**RE: Plan Review Response Letter – Plan Review #ZONE-0008-26
The Station – R010903200005**

Thank you for your plan review email dated February 11, 2026. We have prepared the following information to address your review comments. Please note that for your convenience each review item is restated below along with our corresponding response.

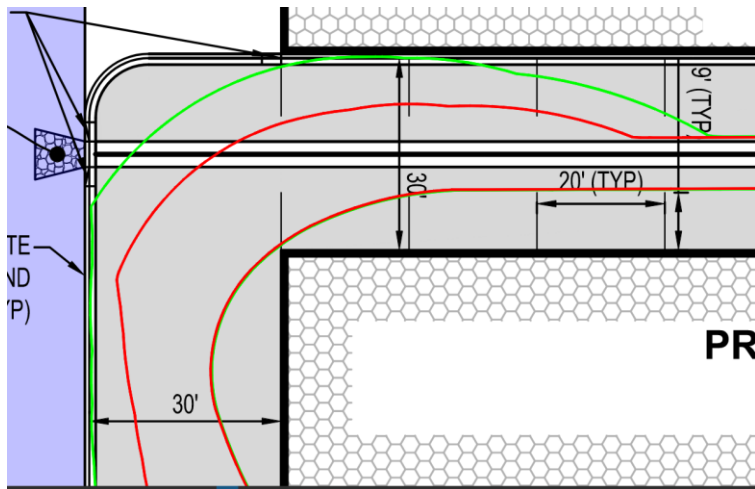
- p. The applicant shall provide clarification regarding the feasibility of fire truck turning movements through the site, notably, the applicant shall address any conflicts caused by insufficient space or off-tracking.

ISG Response: The image below shows there are no conflicts due to insufficient space. The potential conflicts were due to a plotting line weight.
